## HISTORIC PRESERVATION COMMISSION

SUBJECT: Historic Area Work Permit # 1057271 - Roof, HVAC

Applicant: Alexis Gurganious McCarthy  
Address: 10301 Armory Ave., Kensington

**Historic Area Work Permit**  
**10301 Armory Ave Kensington, MD 20895**  
**Work Item #2 – New Roof (cont.)**

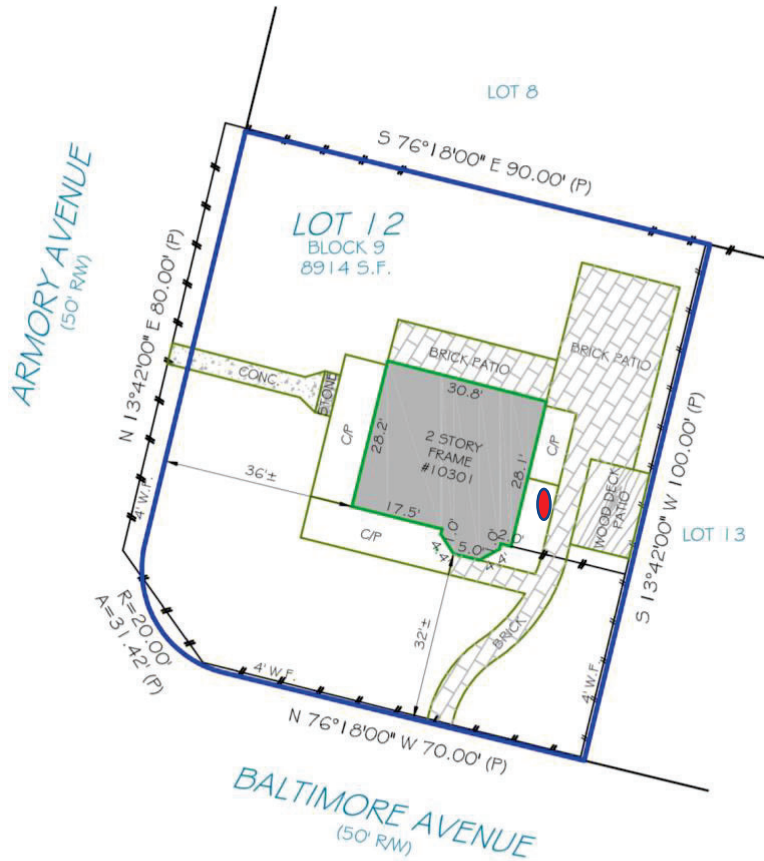
We were recently approved for the HAWP for a new roof using GAF Timberline HDz shingles. However, we just heard from the MHT, and for our state tax credit, they said we must go with the GAF Timberline NS shingle line instead -- a similar product, but more in-line with our current roof, which is fine with us.

Does this slight change impact our HAWP approval, and would it impact approval for any later submission for a Montgomery County tax credit?

Thanks, Rebecca. The new shingle is the GAF Timberline Natural Shadow (NS) line in the color Charcoal. Photo attached.

Thanks for reaching out, we are happy to help. This is a minor change that falls under the staff's ability to approve minor design details. If you can please forward the spec to Chris, and he can stamp the approval along with this email to memorialize the change. The roof MHT is requesting that you use would have qualified for a staff approved HAWP and would not have needed the HPC to approve anyway.

**Historic Area Work Permit**  
**10301 Armory Ave Kensington, MD 20895**  
**Work Item #3– New HVAC (cont.)**

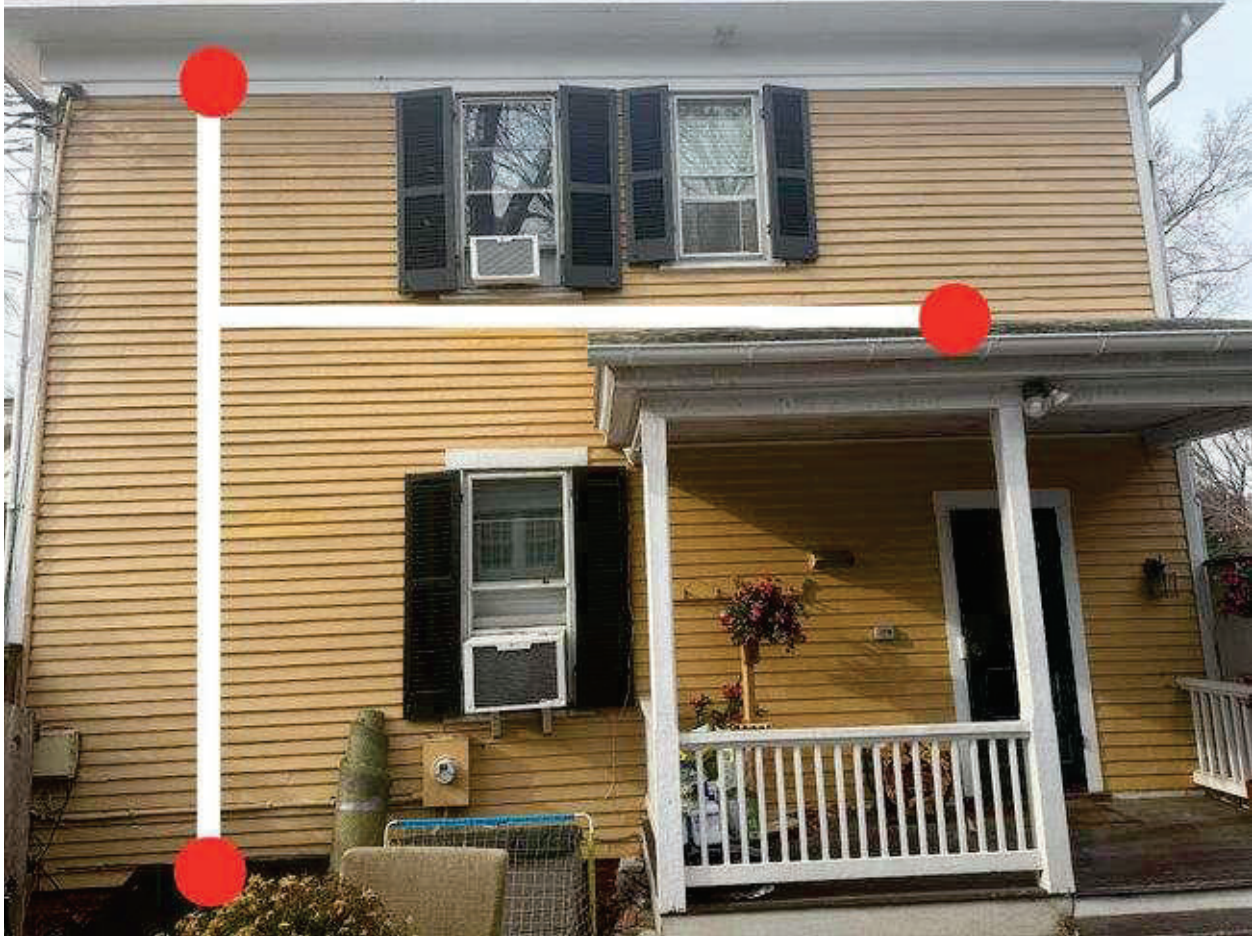
- For the New HVAC, under proposed work, you wrote on the project description that the heat pump units will be on a poly pad, but the photo and diagram says they will be on a 48-by-30 inch concrete pad. Please clarify the pad material.
- Please show the location of the proposed fan coil unit on the exterior wall and provide the unit's approximate dimensions. A specification sheet for the unit or representative photo would also be helpful.
- The proposed concrete pad size is described as 48 inches long on the diagram. Please double check that measurement and confirm there is enough space between the porch and cellar door to fit 48-inch long pad. (It may the stones and board in the photos provided that makes the area appear smaller than reality.) Also provide the distance of the pad from the nearby basement window well.

For the fan coil unit, you wrote on the application under New HVAC, Proposed Work: "The fan coil unit will be mounted on the exterior wall in the back room on the main level and the exterior wall in the kitchen." I'll include your email response as proof the coils will be inside.

The heat pump is approximately 30"X30"X30" and the mini split is approximately 18"X30"X30". In talking to my contractor, there is a ducted coil on the inside units, but not on the exterior units. A photo of the proposed unit can be found on page 10 attached. On the exterior, there will only be three small entry points into the home, outlined on page 8 attached. Please let me know if I misunderstood your question.
